Product /Process Change Notification

4PCN-20260121

Description of Change

Liteon plans to replace lead frame used in **LTW-206** series, due to an end-of-life (EOL, 10L474-3) notification from the current lead frame supplier.

Old lead frame (10L474-3)	New Lead frame (10L474-D)

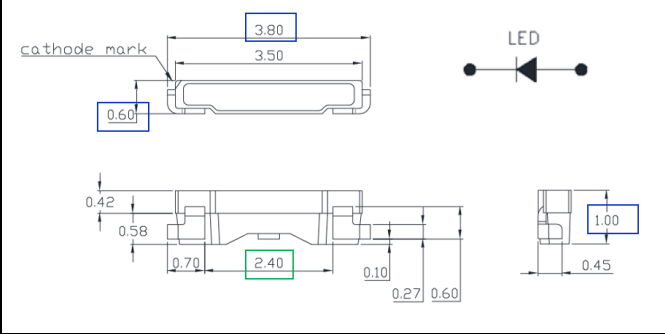
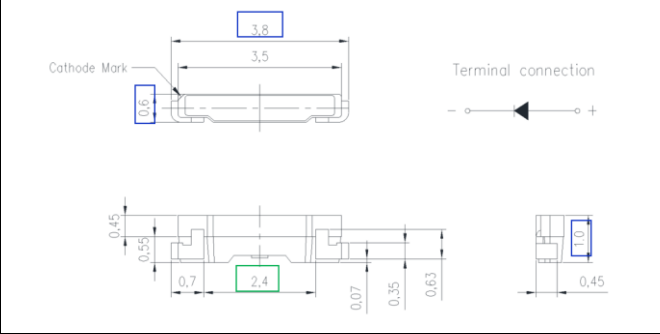
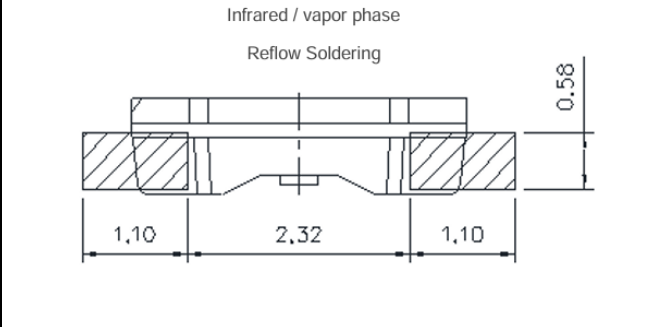
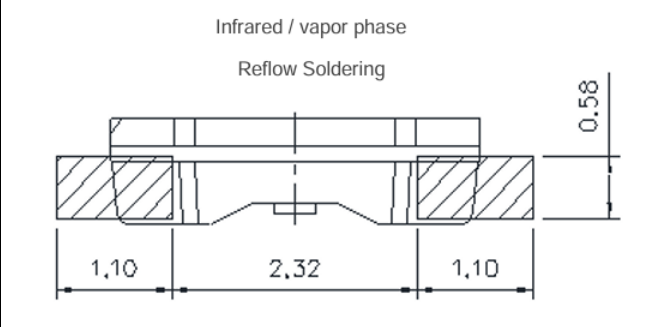
The **LTW-206** lead frames have an end-of-life (EOL) due to the supplier, we will conduct lead frame replacement as shown below.

Running change from 2026/09/01.
